Calcaterra Estates

City of El Paso — City Plan Commission — 7/12/2018

SUSU18-00038 — Resubdivision Combination

1: The applicant is requesting an Alternative Design for the proposed Cross-Section D-D as per 19.26.040 – Alternative subdivision improvement design.

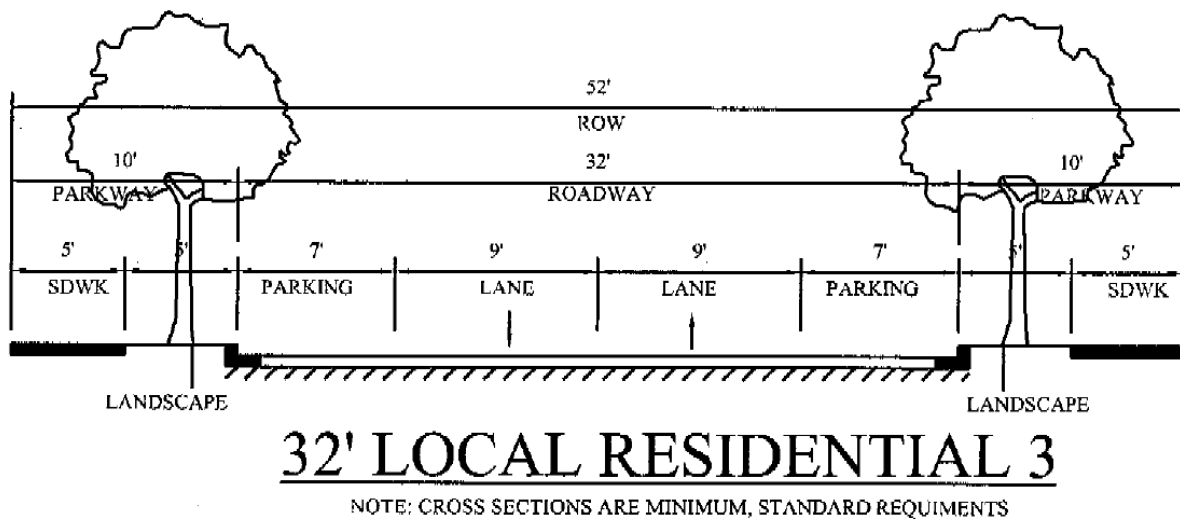
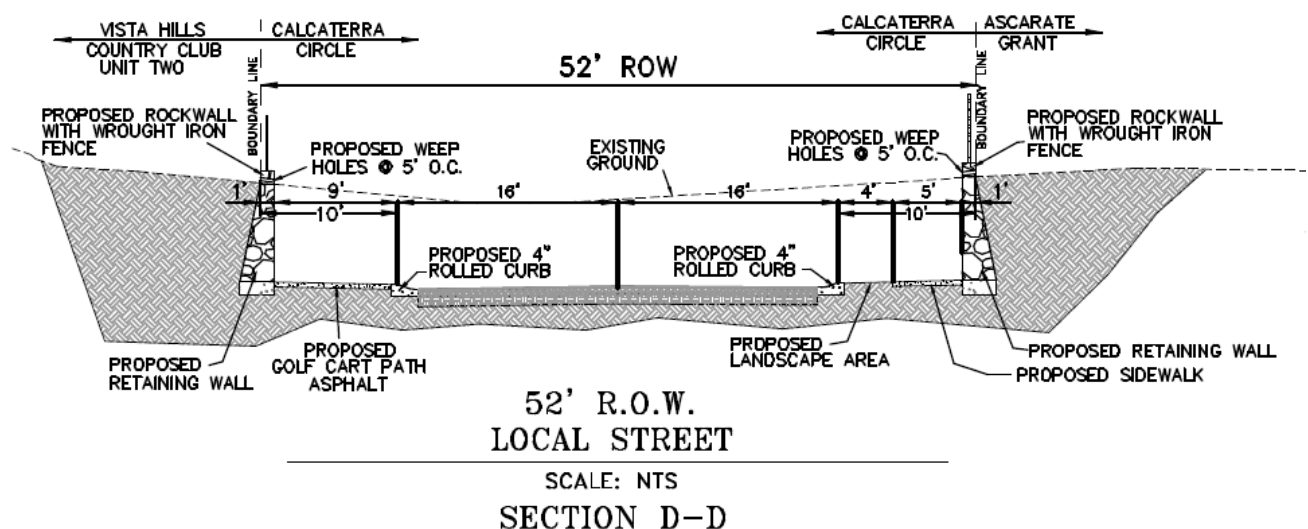
- Per the DSC, the local street requires a 32' roadway with a 10' parkway consisting of a landscape buffer and a 5' sidewalk.
- The applicant proposes a 32' roadway with a 10' parkway consisting of a 9' golf cart path and a 1' retaining wall extension adjacent to the Vista Hills Country Club Unit 2 subdivision and a 10' parkway consisting of a 4' landscape buffer, a 5' sidewalk, and a 1' retaining wall extension adjacent to the Ascarate Grant tract (Hole 9).
- Streets and Maintenance has recommended approval of the alternative design request.
- This is a private street.

Streets & Maintenance has no issue with the proposed alternative design. However, the applicant should be aware that should the subdivision, in the future, petition to have the streets made public, the process may be complicated by the right-of-way design, as it does not meet the DSC.

2: The applicant is requesting the following exception under 19.10.050-A (Roadway participation policies) for Cross-Section C-C:

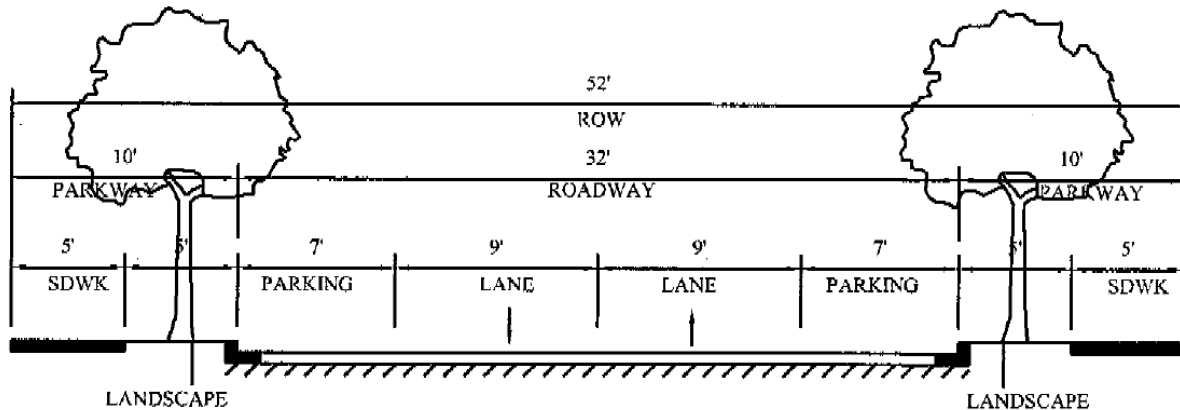
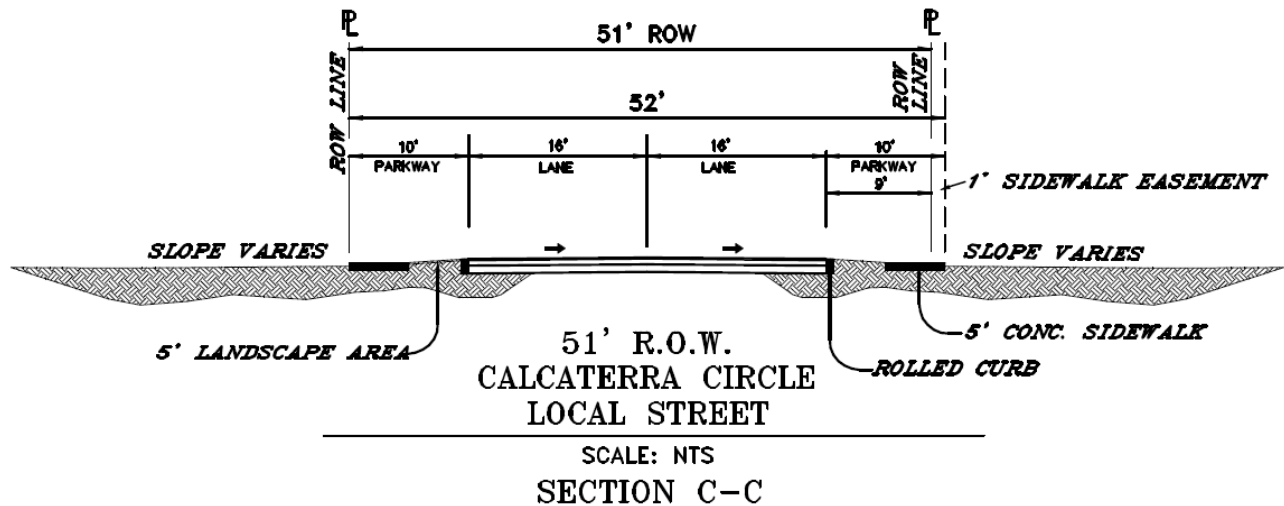
- To waive 1' of the required 10' parkway from the north side of Blocks 2 and 3.
 - The parkway requires 10' consisting of a 5' landscape buffer and a 5' sidewalk. The proposed cross-section's parkway is a 5' landscape buffer and a 4' sidewalk.
 - An additional 1' of sidewalk is located on private property and will be available to the community through an access easement.
 - The appearance of the street will still be that of a 52' right-of-way as the sidewalk becomes 5' with the access easement.
 - This is a private street.

The applicant meets the intent of the DSC standard for Waiver #2 as the physical layout of the right of way will be to that of the DSC standard. The following criteria under Section 19.10.050 (Roadway participation policies – Improvement of roads and utilities within and or abutting the subdivision) is requested as the exception. The section reads as follows:

ATTACHMENT 3

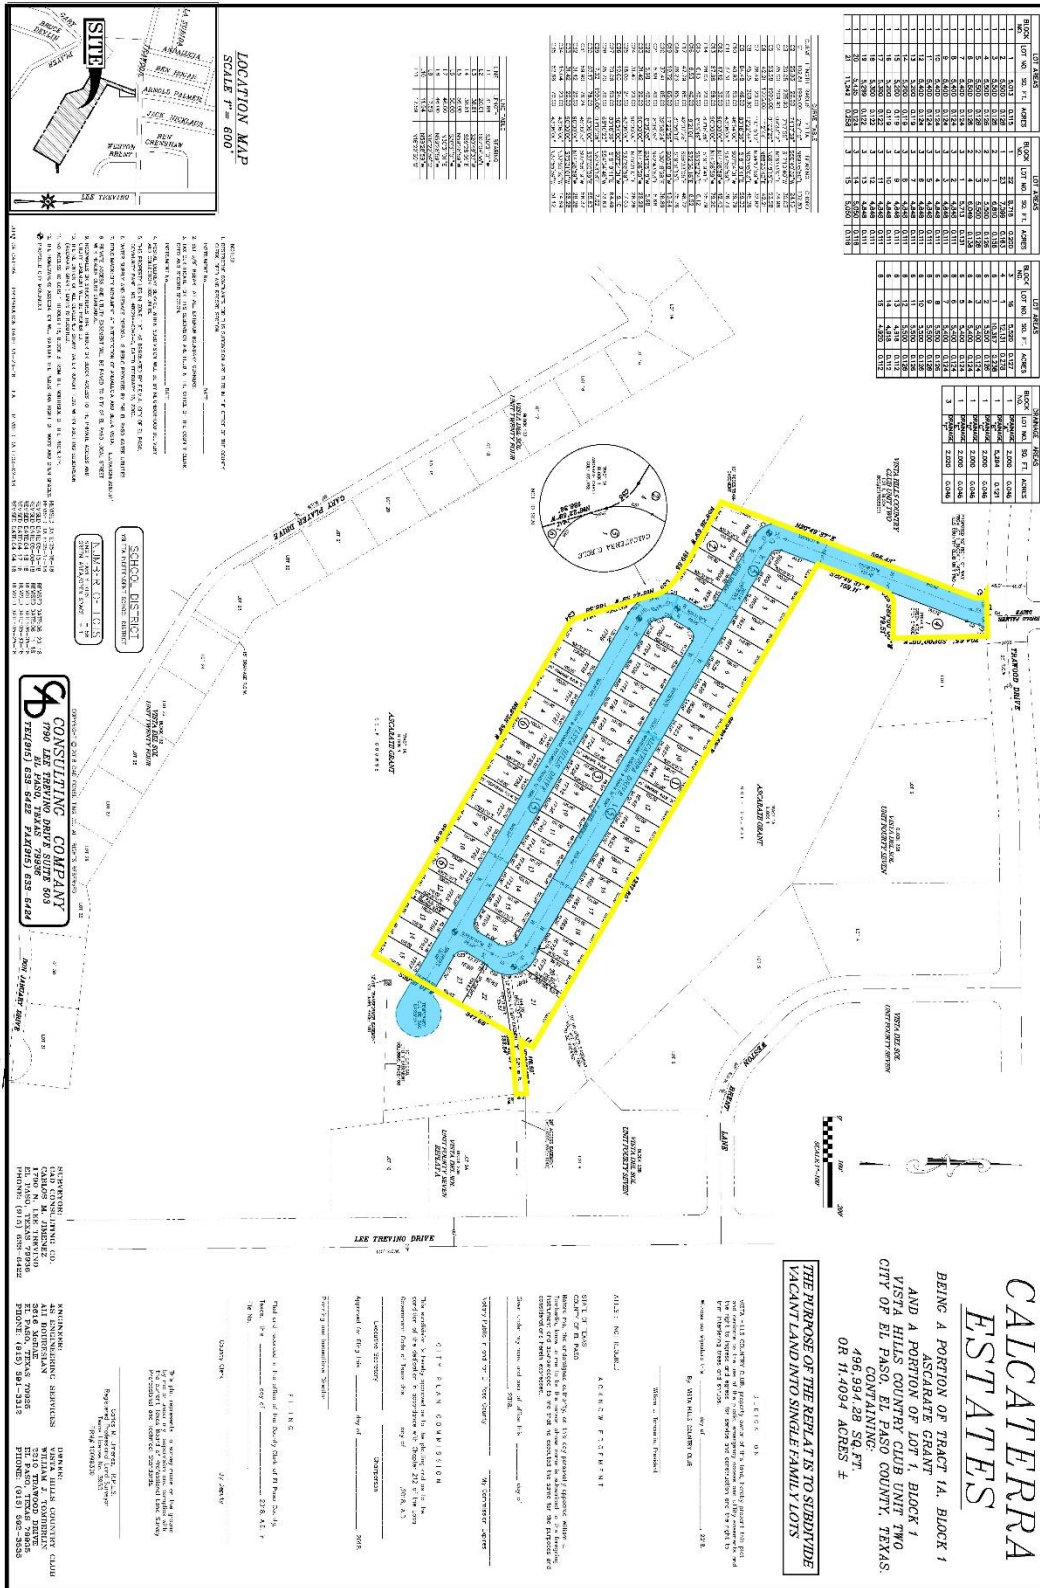
1: The chain link fence must be removed entirely or relocated off of the public right-of-way and placed onto private property.

4: The easement that runs through lots 19 and 20 of Block 1 needs to have a note stating that the easement will be vacated by a separate instrument number. The separate instrument number must be recorded with the El Paso County Clerk's Office prior to the recording of the subdivision.

- 1: Provide a monument at the curved portion of Calcaterra Circle near Lot 1 Block 3.
- 2: Clarify if 20' access easement entirely lies within lot 21 or 22 by providing a solid lot line. Also define if it is to be a private or public access easement.
